MUSIC MAN, INC.  
1338 State College Parkway  
P.O. Box 4589  
Anaheim, California 92803  
(714) 956-9220  
Telex 692-397

SERVICE BULLETIN #1

*RD-100 & RD-65 - HD150 & HD75*

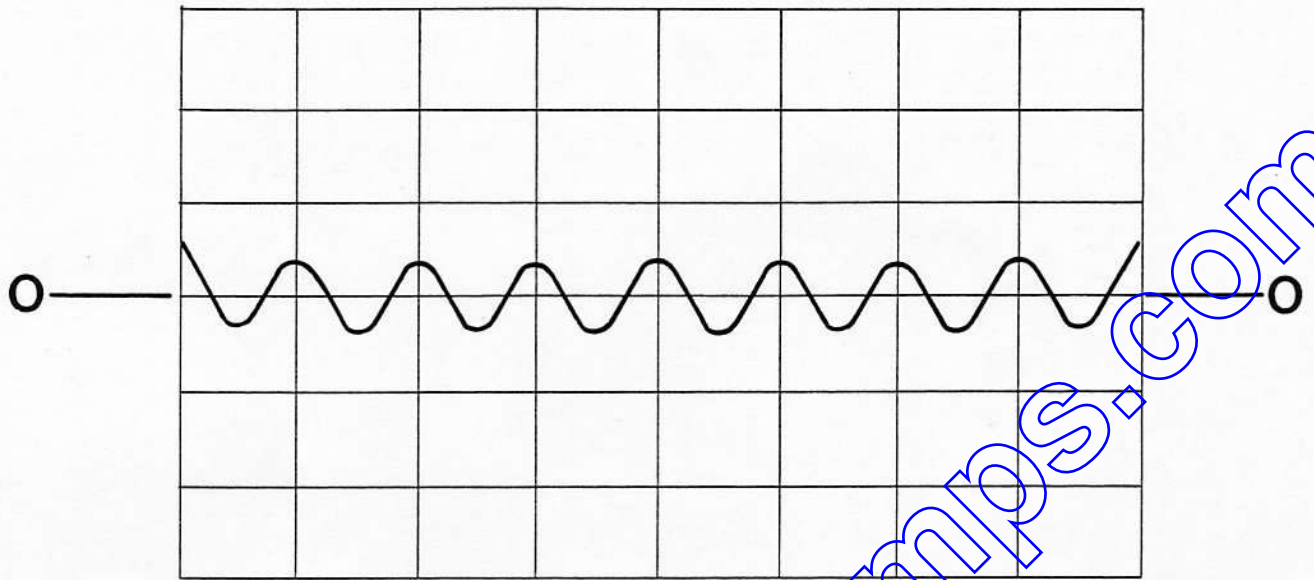
4. Turn up the channel volume until you achieve 4 volts peak to peak at the output of the preamp. (purple wire)
5. Slowly turn the tremelo modulation trimmer clockwise until both halves of the sine wave reach their lowest amplitude. (Just before phase reversal) The pattern on the scope should resemble fig. 1.

**FIG. 2**

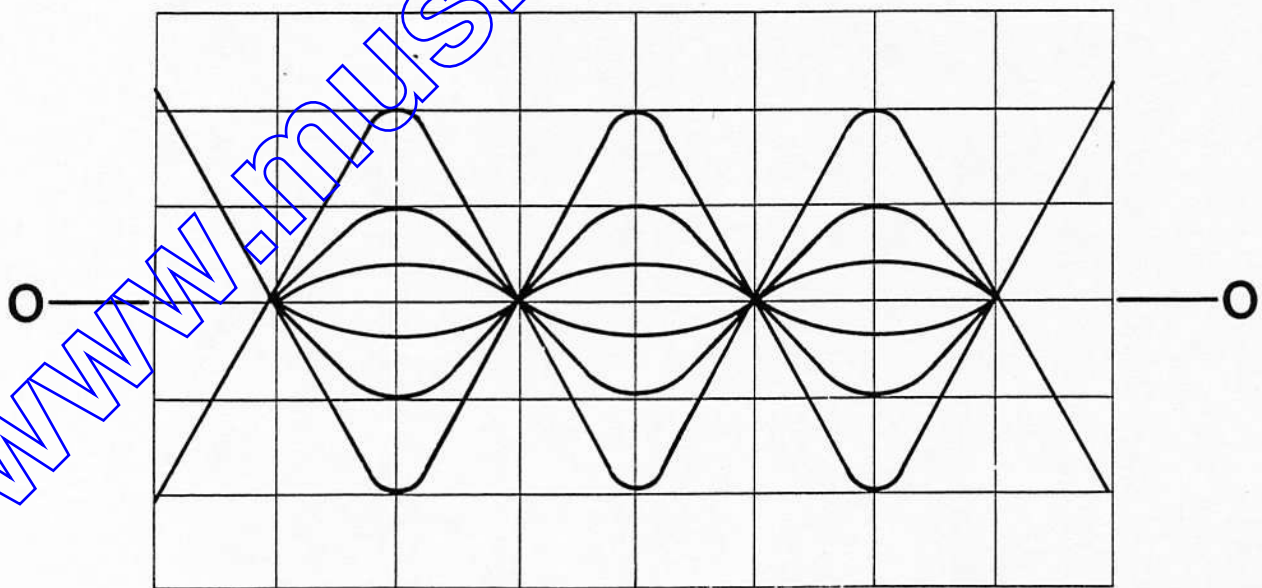
6. Replace the low frequency oscillator transistor and the pattern on the scope should resemble fig. 2.

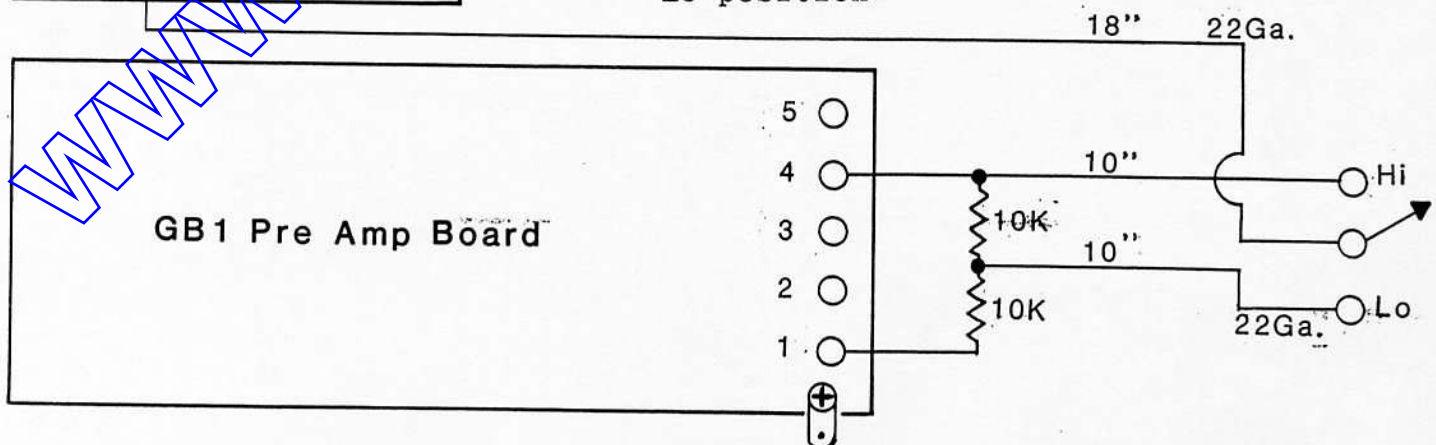
11. Twist the leads of two 10K $\frac{1}{2}$ W resistors together so that they form a series configuration. Attach one end of a 10" inch piece of 22 gauge wire to the point at which the two resistor leads are twisted together. Attach the other end of the wire to the upper lug of the HI-LO switch on the front panel. Attach the remaining lead of one of the 10K resistors to eyelet #4 located on the far right side of the GB-1 preamp circuit board. (Looking from the front and counting from front to back.) There will be a grey wire soldered to eyelet #4. Cut this wire to a length of 10" inches leaving one end soldered to eyelet #4. Attach the other end to the bottom lug of the HI-LO switch. Attach the lead of the remaining 10K resistor to eyelet #1.

12. Attach an 18" inch length of 22 gauge wire to the center lug of the HI-LO switch. Attach the other end of the wire to the eyelet on the DB-1 driver board where the grey wire from the GB-1 preamp board used to connect.

NOTE: The two 10K resistors in this circuit act as a voltage divider network. The negative grid bias voltage should drop by half when the HI-LO switch is in the LO position

FIG. 2

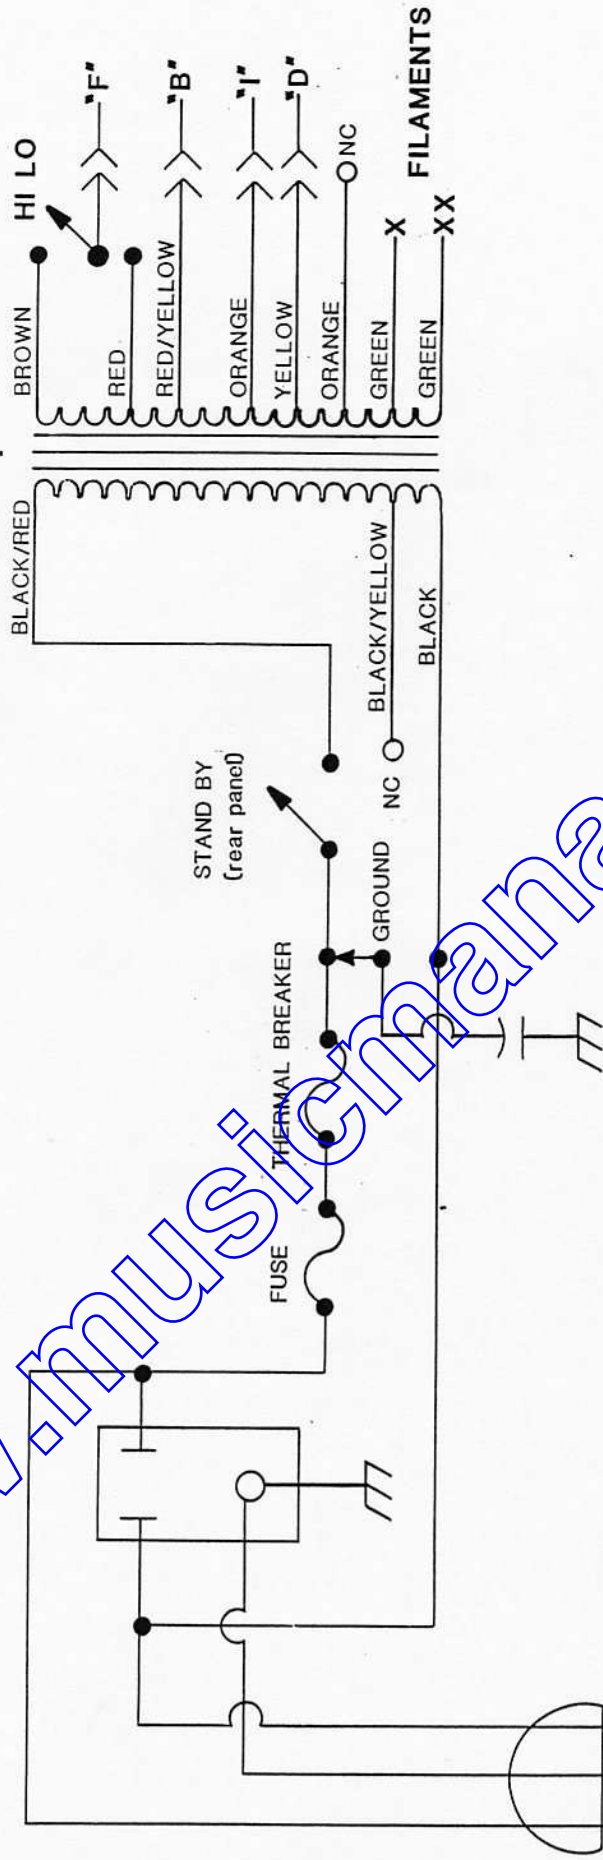
9. Attach the two green filament windings to the terminal strip in the same place as the originals. (On the 200-130 power transformer there are two windings for each side of the filaments. Attach yellow/green to yellow/green and green to green.) Use wire ties and "bundle" the wires in a neat fashion. Refer to fig. #2 to check wiring before turning on the amp.

FIG. 1

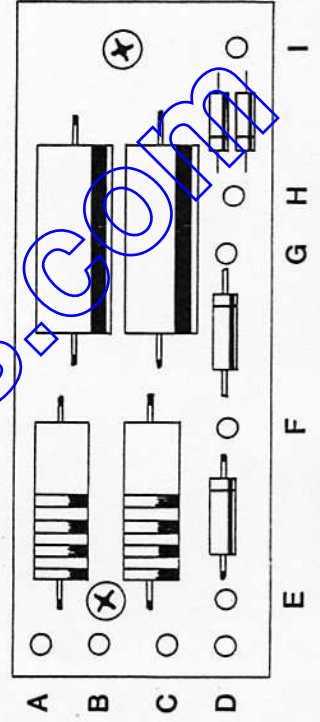
4. Remove the .047 capacitor from the Hi/Lo power switch on the front panel. Using fig. #1 as a guide, attach an 8 inch length of 18 gauge white wire from the center lug of the Hi/Lo power switch to point "F" on the RB-1 rectifier board. The RB-1 rectifier board is located in the right rear corner. (looking from the front)

### RF MODIFICATION DRAWING

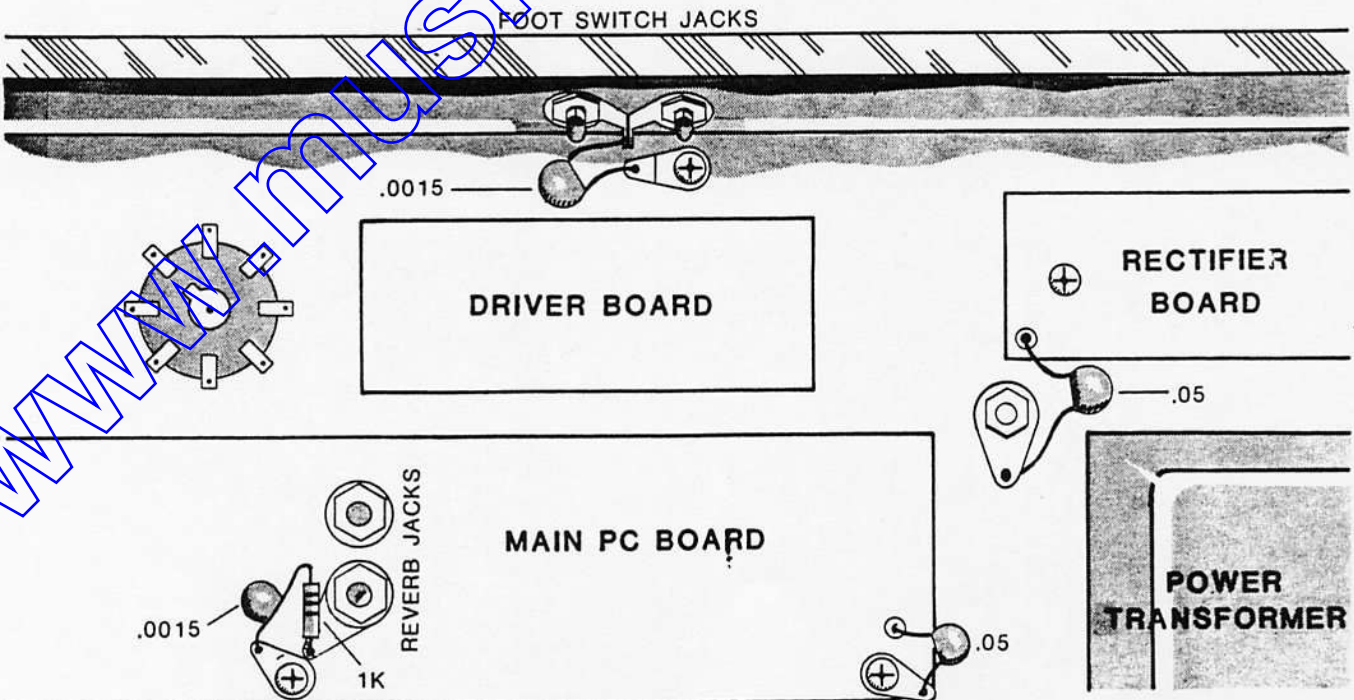
1. (a) Install solder lug to chassis with output transformer mounting screw (located below footswitch jacks).
- (b) Solder .0015mf ceramic capacitor from solder lug to footswitch jack ground lug.
- (c) Install solder lug onto power transformer mounting bolt with extra kep nut.
- (d) Solder .05mf ceramic capacitor from solder lug to ground eyelet on rectifier board (corner eyelet).
2. (a) Install a solder lug on the main PC board under the bottom center board mounting screw.
- (b) Solder a .0015mf ceramic capacitor from the solder lug to the reverb spring jack ground. This can be done by soldering to the top lead of 1K resistor near the return jack.

1. Check for a .05mf ceramic capacitor installed from power supply ground (bottom right corner eyelet) to chassis ground (solder lug under corner PC board mounting screw). If it is missing, install one.
2. A very successful deterrent to RF is replacing the LM307H ICs with those of a bifet type such as the LF351H manufactured by National Semiconductor and others. These do not rectify RF. You may get by just replacing the input amplifiers, the reverb spring amplifier and the summing stage.

3. If the bifet ICs are unobtainable, a temporary solution would be to install 100pf capacitors from pin 2 to pin 3 of various ICs. This is a partial deterrent to RF especially when applied to the input amplifiers. A .001mf ceramic can be installed on the reverb return spring amplifier (pins 2 and 3).

4. Installation of .1mf ceramic capacitors from supply lines to ground will help eliminate RF and voltage spikes from appearing on the supply lines.
